Administrative Approval Action

Case File / Name: ASR-0024-2023

DSLCL - PLEASANT VALLEY PROMENADE MULTIFAMILY

SHEET NUMBER:
A107

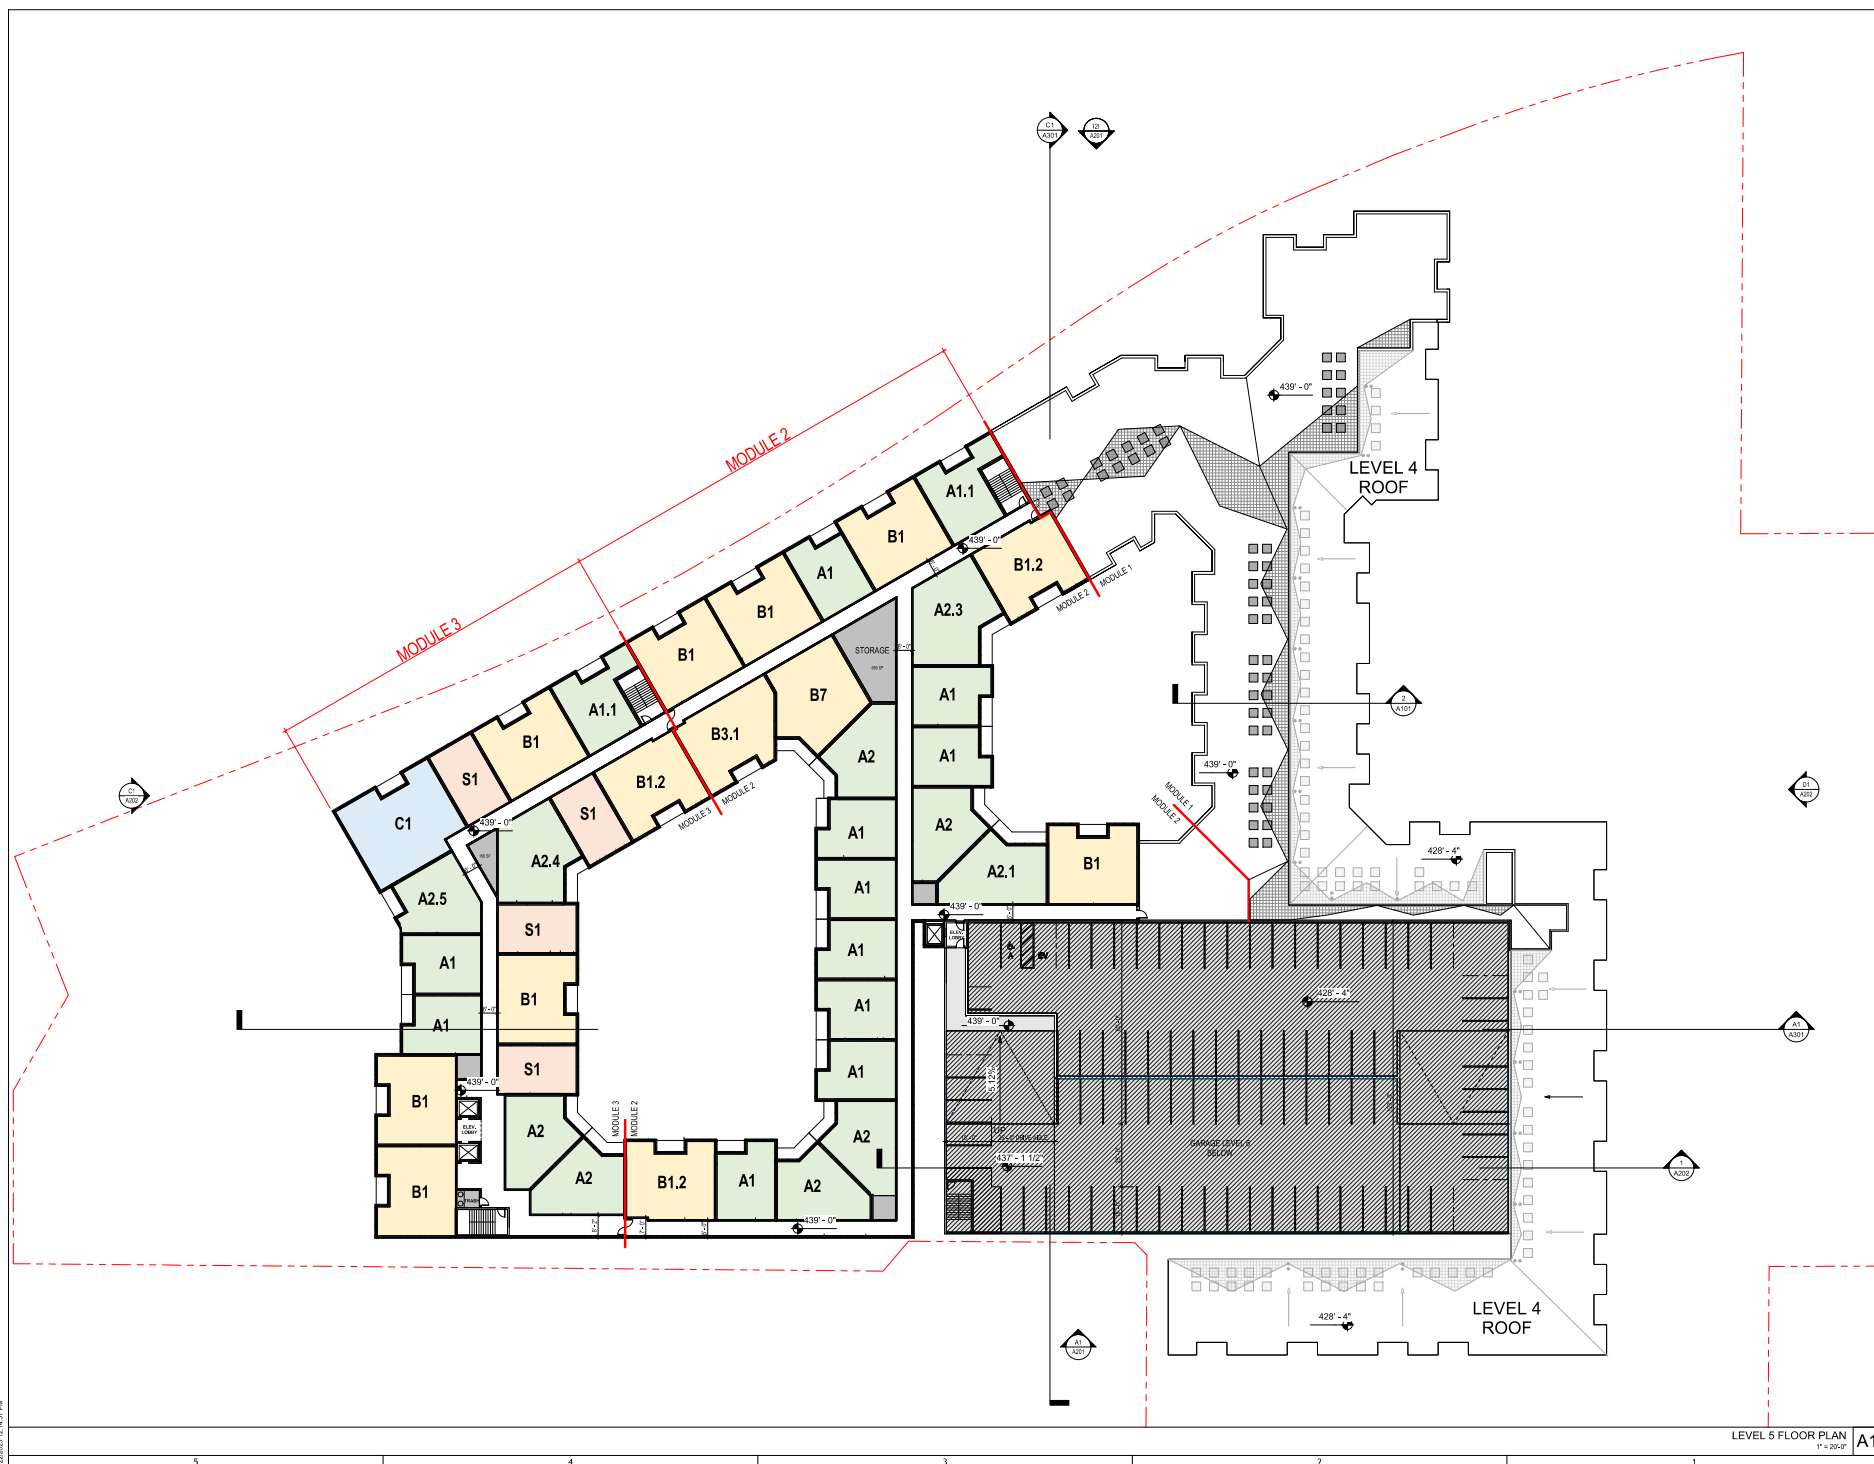
8. Update sheets G003-G004 and A106-A108, by providing clarity with a legend for the hatched areas being shown on all sheets, and identifying the structure being shown on sheet A107. Lastly, amend the labeling on sheet A108 for the garage deck level per the rooftop plan shown.

NORTH ELEVATION 1/16" = 1'-0"	B1
----------------------------------	----

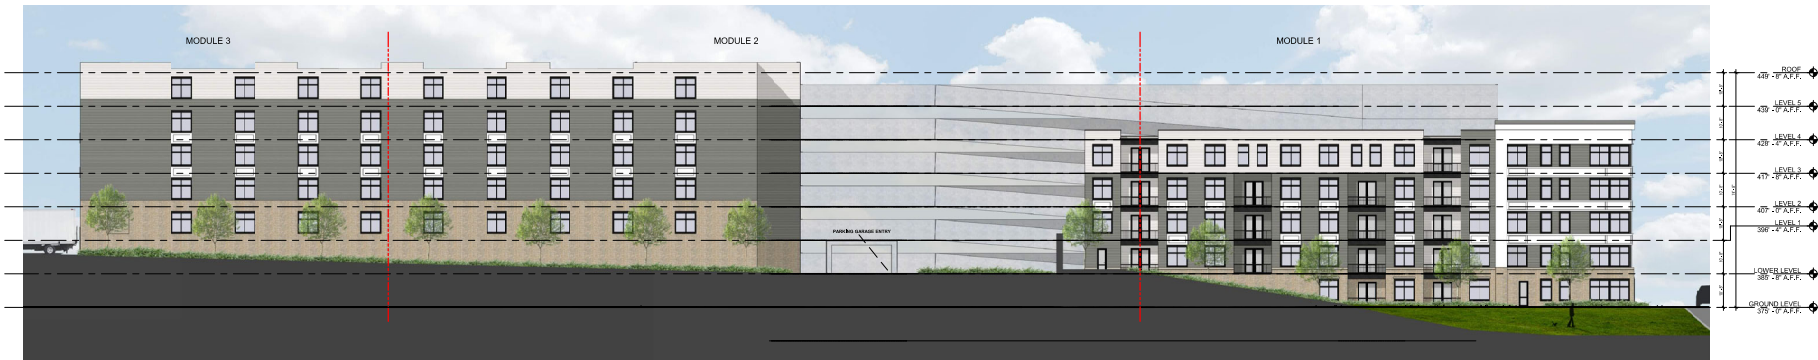
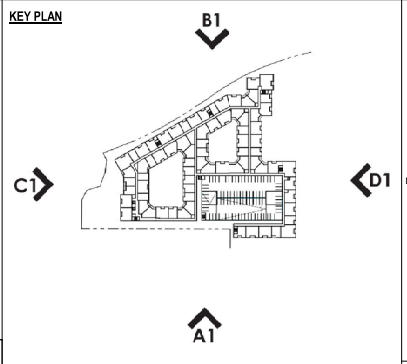
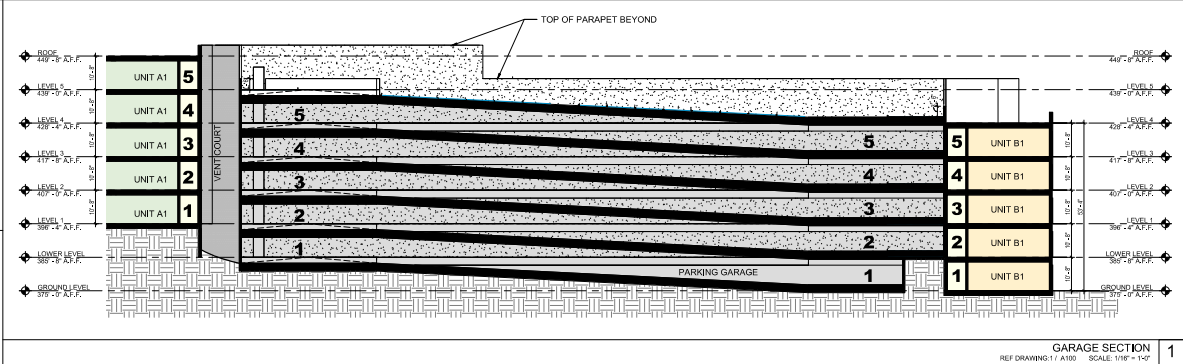
2. The transparency data calculation table for the non-residential portion(s) of building module #3, as shown on sheet A201, are revised as shown and demonstrate compliance with UDO Sec.1.5.9.B.
